EMS STATION RENOVATIONS**ADDENDUM NO. 2****EAST RALEIGH EMS STATION 7**

WAKE COUNTY REQUEST FOR BIDS NUMBER: RFB #26-082

DATE: **SEPTEMBER 10, 2026****BID DATE, TIME, AND LOCATION HAVE NOT BEEN CHANGED.**

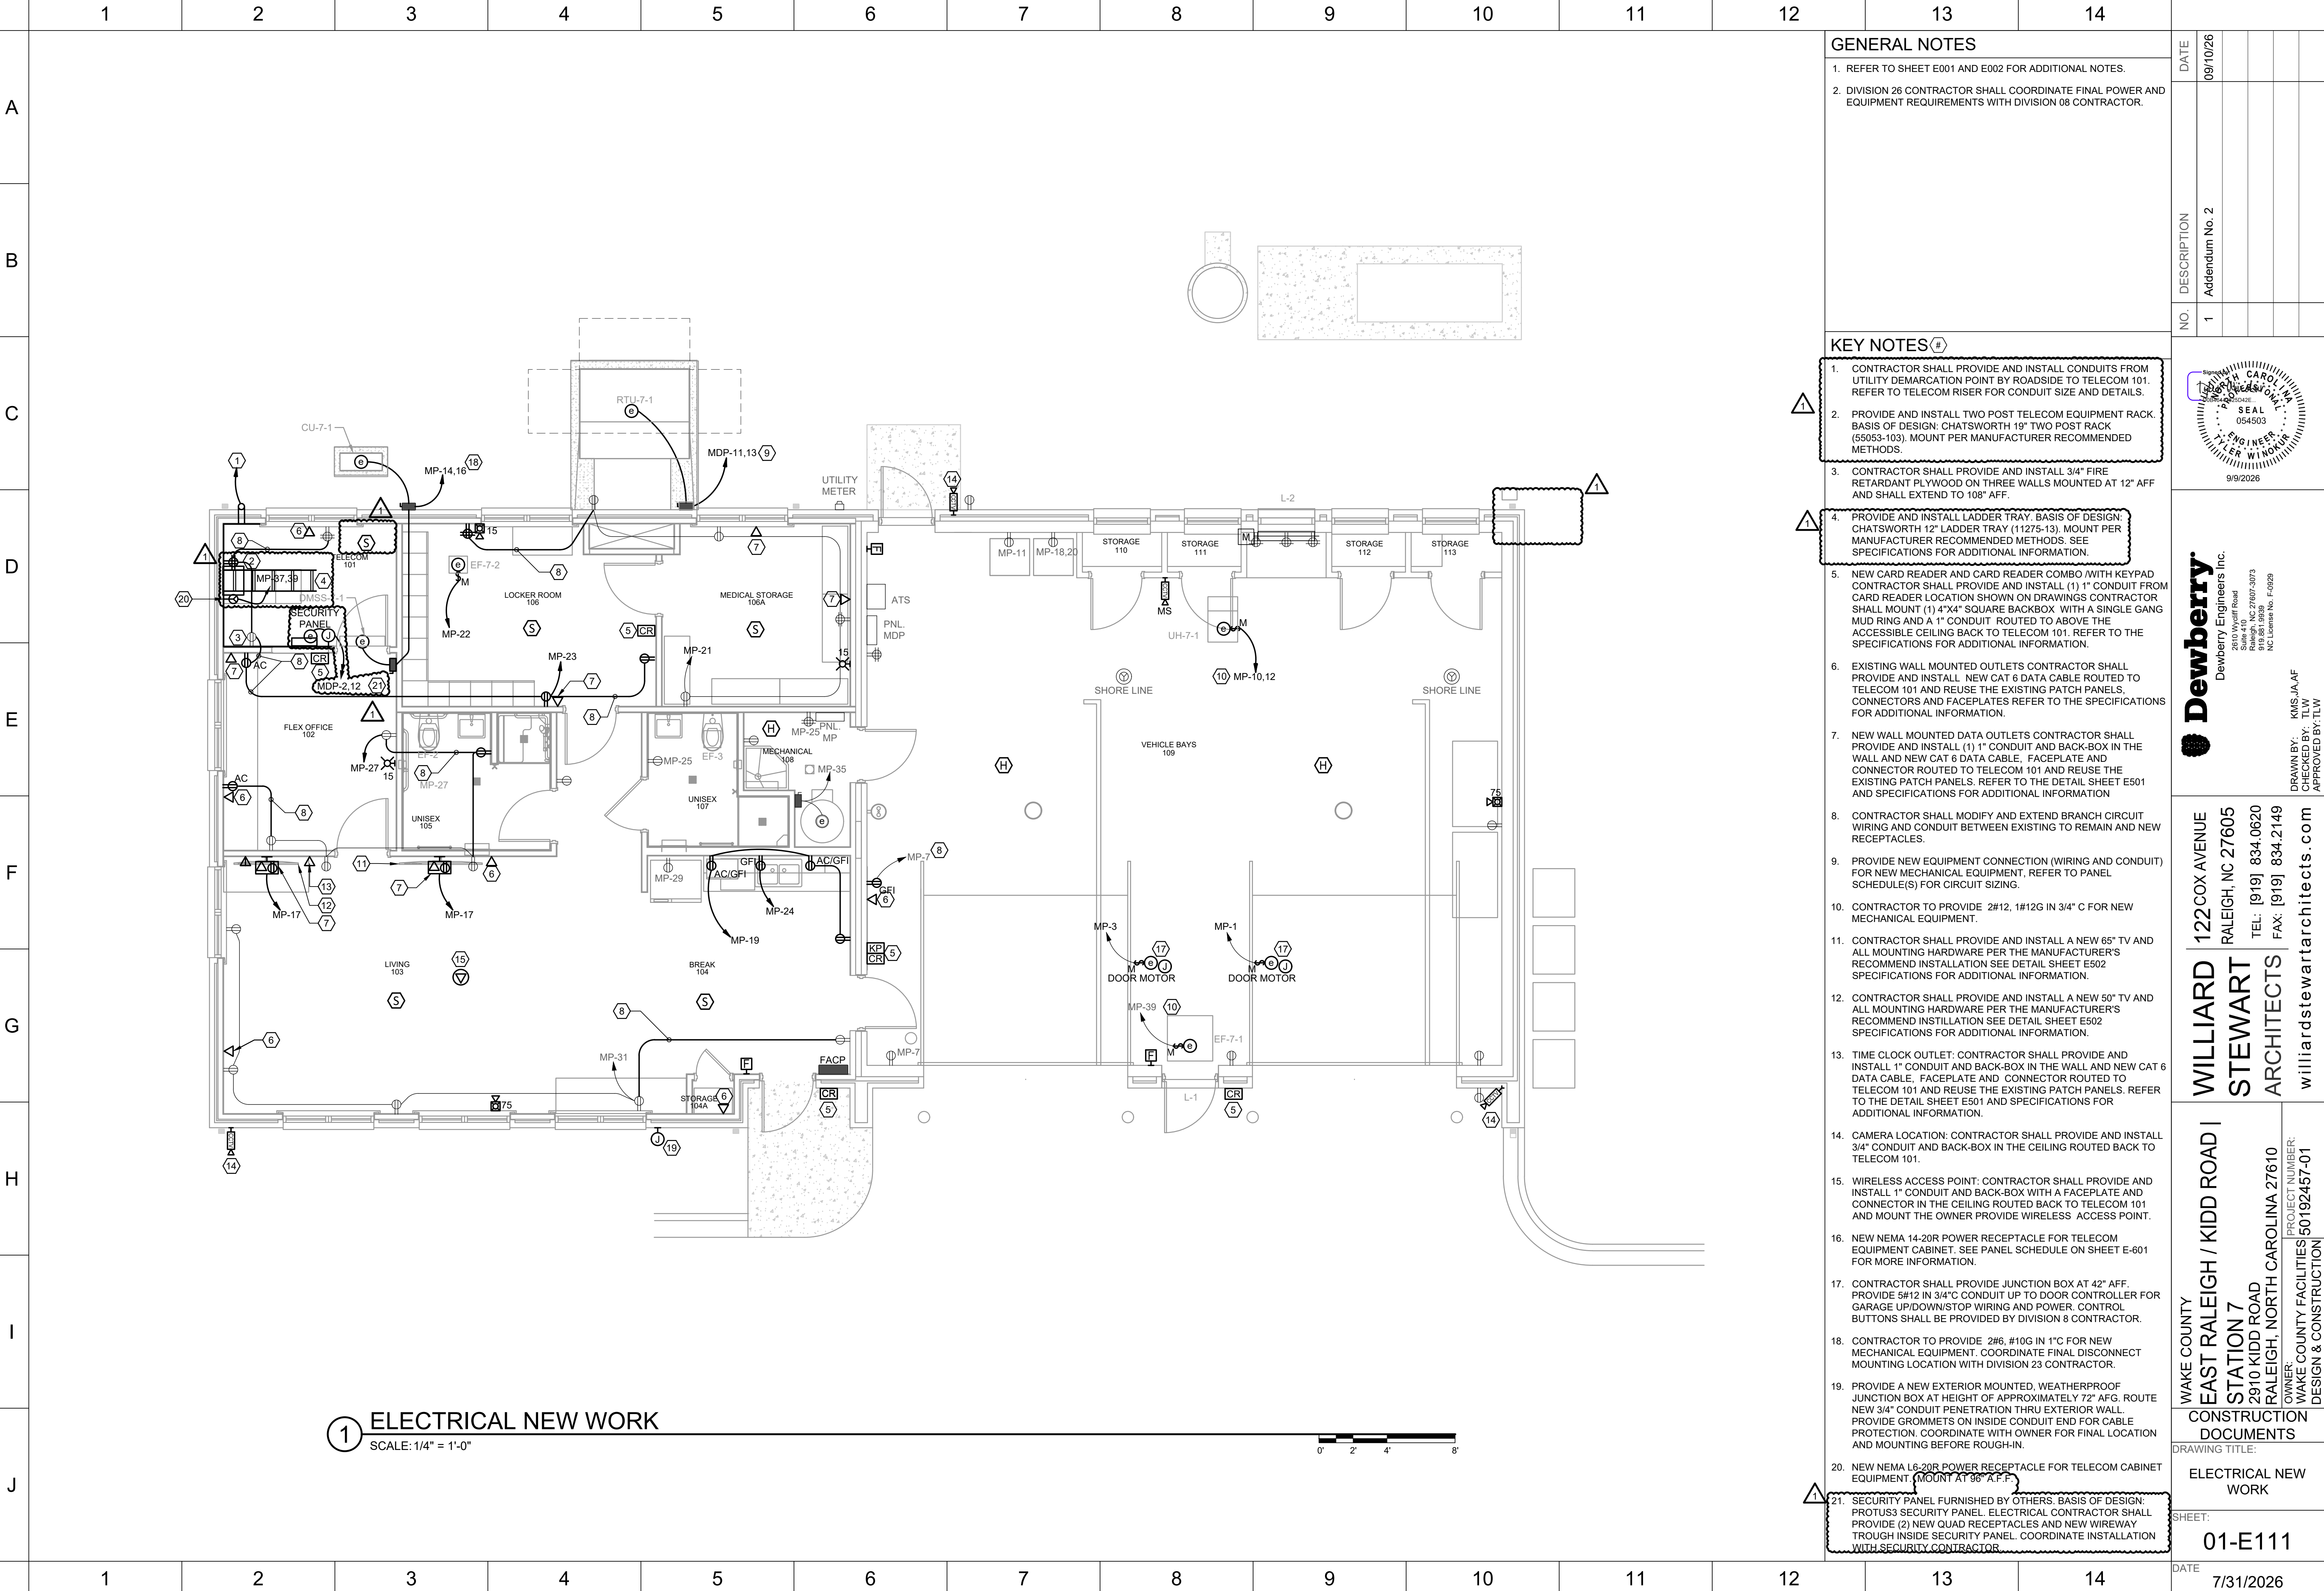
1. **REPLACE** Sheet 01-M601 – Schedules with the attached, updated 01-M601 – Schedules (Revision 1, Dated 09/10/26). DMMS-7-1 Refrigerant Calculations added. DMMS-7-1 tonnage updated, and refrigerant leak mitigation added.
